UNITED STATES PATENT AND TRADEMARK OFFICE

APPLICATION NO.	FILING DATE	FIRST NAMED INVENTOR	ATTORNEY DOCKET NO.	CONFIRMATION NO.
10/645,089	08/21/2003	David Ernest Hartley	PA-5340 -RFB	7302
9896 7590 06/23/2009 COOK GROUP PATENT OFFICE P.O. BOX 2269 BLOOMINGTON, IN 47402				
EXAMINER TOWA, REINE T				
ART UNIT 3736		PAPER NUMBER		
MAIL DATE 06/23/2009		DELIVERY MODE PAPER

Office Action Summary**Application No.**

DETAILED ACTION

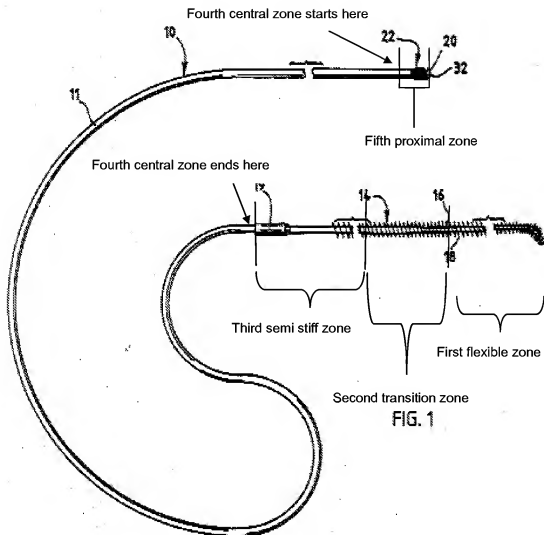
In regards to **claims 48-49, Rodriguez et al.** disclose a guide wire 10, the guide wire 10 having 5 zones of varying stiffness (see drawing below) comprising:

- (a) a proximal end and a distal end;
- (b) a fifth proximal zone adjacent the proximal end and having a semi-stiff proximal portion, a distal portion of high-stiffness, and a transition portion transitioning from the semi-stiffness of the proximal portion to the high stiffness of the distal portion, the proximal zone having a length of about 5 cm (i.e. "the proximal end tip preferably has a length of no more than about two inches") (see col. 2, lines 27-31);
- (c) a fourth elongate central zone of high stiffness adjacent the proximal zone having a substantially constant diameter along its length; and,
- (d) a distal zone adjacent to the high stiffness central zone and having a proximal portion of high-stiffness adjacent to the distal portion of the central zone and transitioning to a distal portion of highest flexibility when the distal zone comprises three zones:

(i) a third semi stiff zone having a proximal portion of high stiffness adjacent to the distal portion of the central zone transitioning to a distal portion of semi-stiffness;

(ii) a second transition zone having a semi-stiff proximal portion adjacent to the distal portion of the semi-stiff zone transitioning to a flexible distal portion; and,

(iii) a first flexible zone adjacent to the distal end and having a flexible proximal portion adjacent to the distal portion of the transition zone transitioning to a distal portion of at least stiffness and highest flexibility;

wherein the proximal zone comprises a proximal wire coil 30 of substantially constant diameter and the distal zone comprises a distal wire coil 18 of substantially constant diameter (see figs. 1-2; col. 2, lines 19-20, 27-31, 42-44 & 66-68; col. 3, lines 26-29 & 41-44; see claims 1 & 4 of Rodriguez);
